Planning Application No. A/YL-SK/466

Table A: Responses to Departmental Comments

Proposed Temporary Shop and Service and Associated Filling of Land for a Period of 3 Years at Various Lots in D.D.114, Shek Kong, Yuen Long, N.T.

Land Filling Plan

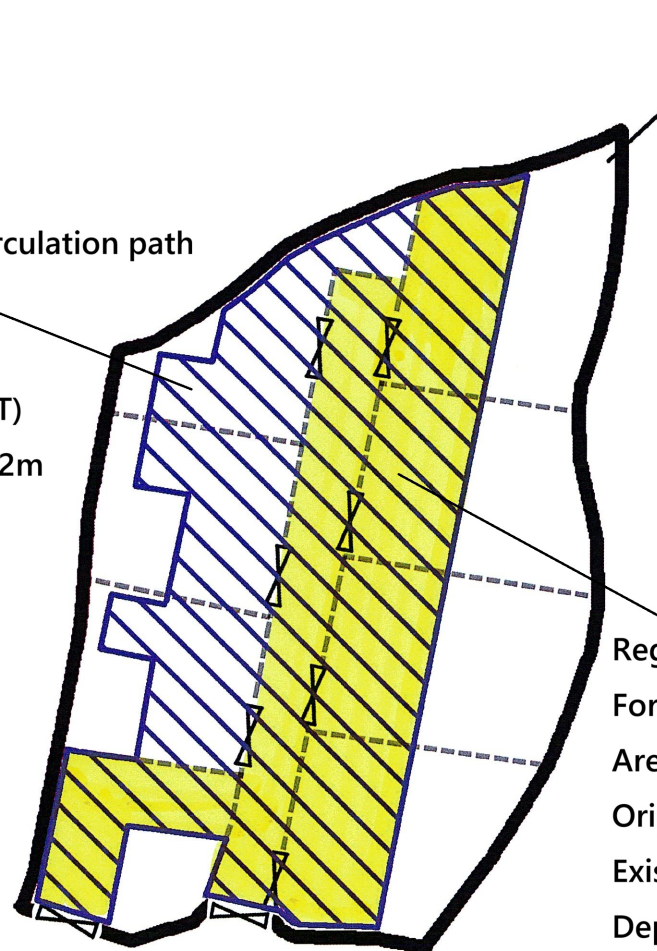
Departmental Comments	Responses
	Comments from Fanling, Sheung Shui & Yuen Long East District Planning Office, Planning Department	
1	It is noted that the application applies for filling of land of a total area of about 1,050m ² (about 64% of the Site). Please clarify on the area intended for proposed land filling and that intended for regularization of land filling, and please update the relevant plan/drawing, as appropriate.	擬議申請的總填土面積約為 1,050 平方米，區分如下； 1. 已填土部分規範化的面積 (Regularization of land filling) 約為 650 平方米 (圖則中以黃色標示) 2. 擬議填土的面積 (Proposed land filling) 約為 400 平方米 有關上述兩部分的具體位置，請參閱附件 1。

Area: 400m² (ABOUT)

Existing site level: +34.7mPD (ABOUT)

Proposed site level: +34.9mPD (ABOUT)

Depth of land filling : No more than 0.2m

Area: 650m² (ABOUT)

Original site level: +34.7mPD (ABOUT)

Existing site level: +34.9mPD (ABOUT)

Depth of land filling : No more than 0.2m

Total Land Filling Area = 1050 m² (ABOUT)
